ATTACHMENT B TO BECO 92-012

Revised Technical Specification Pages

PNPS Table 3.1.1

Figure 4.1.1 GRAPHICAL AID IN THE SELECTION OF AN ADEQUATE INTERVAL BETWEEN TESTS

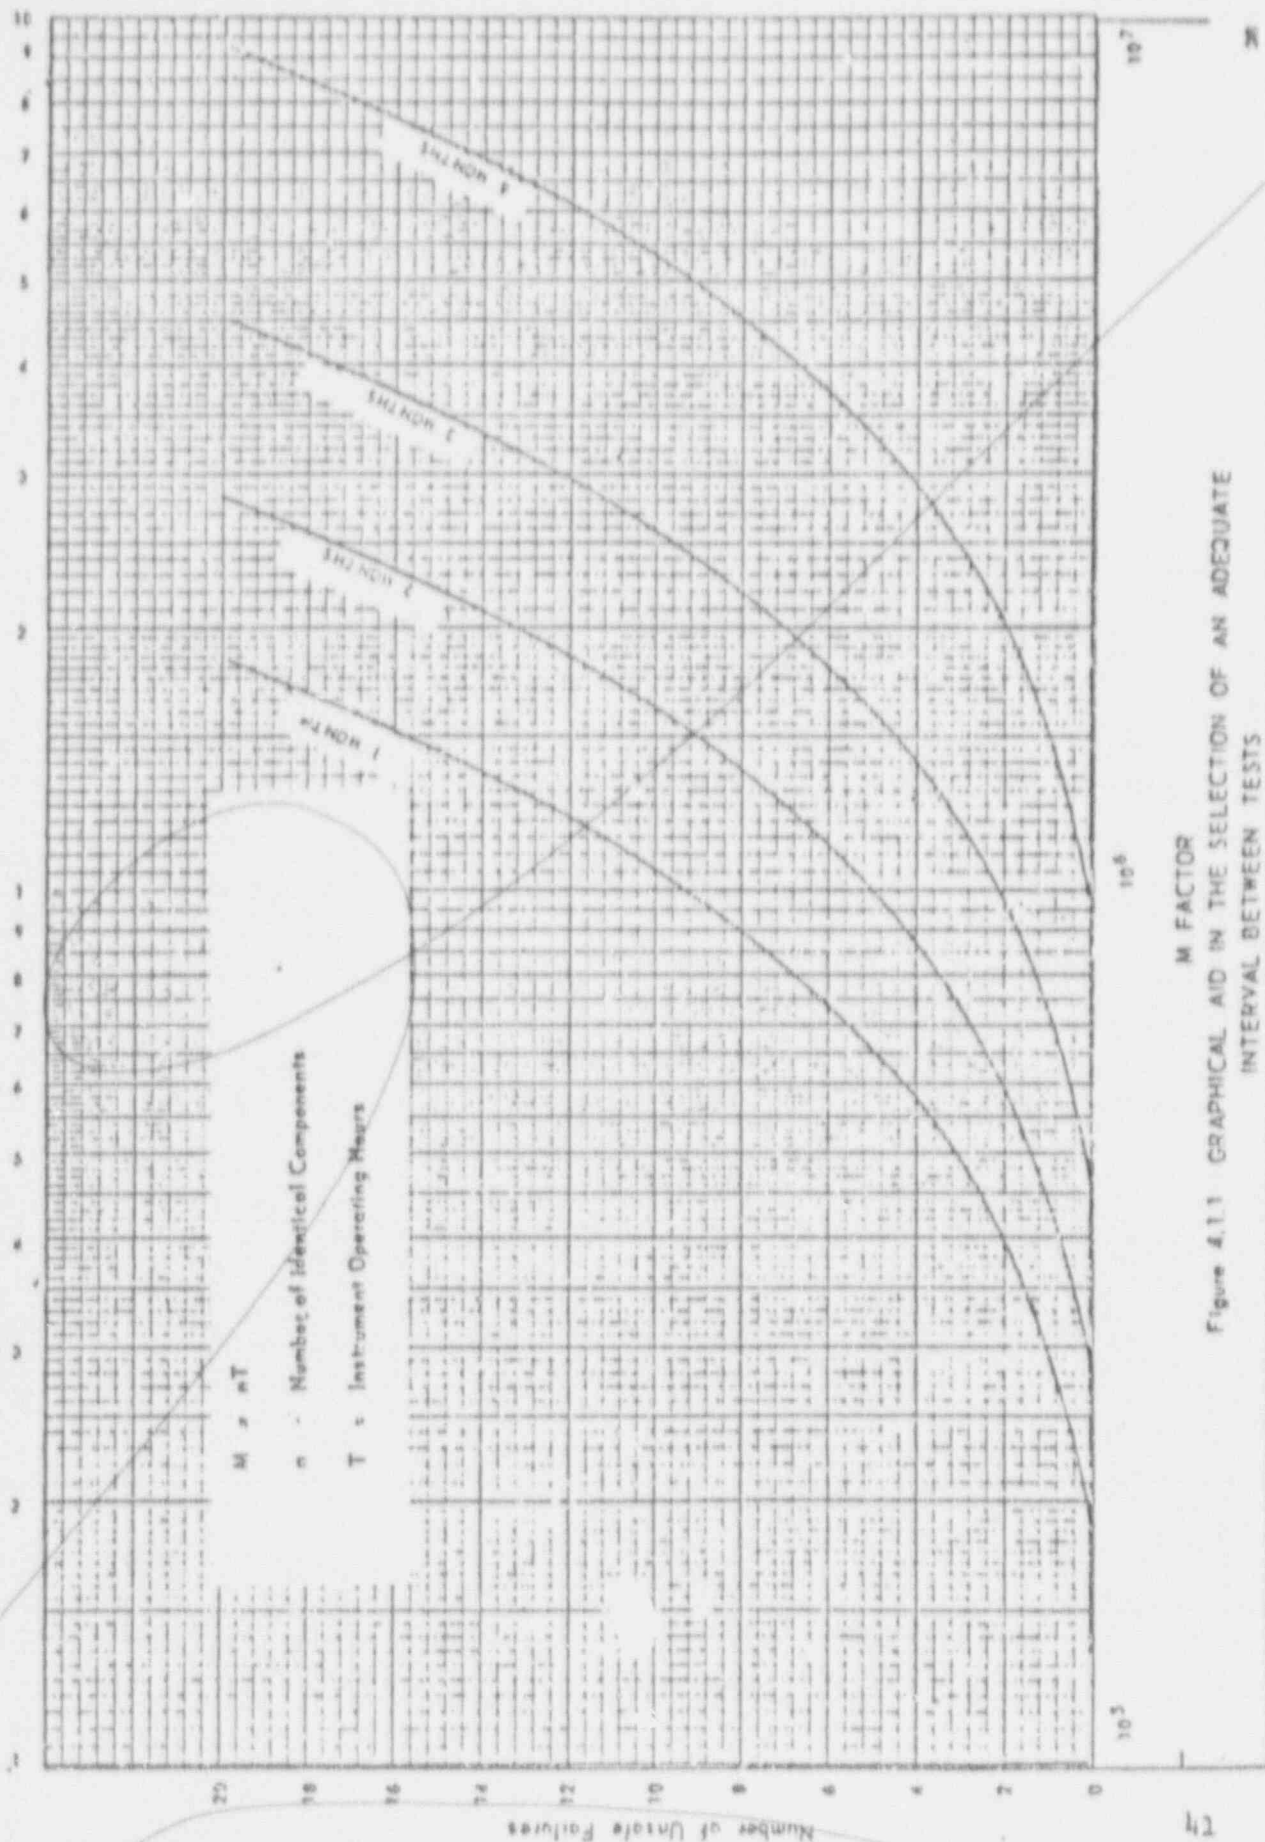
Figure 4.1.1 is deleted and the p. 41 is intentionally left blank.
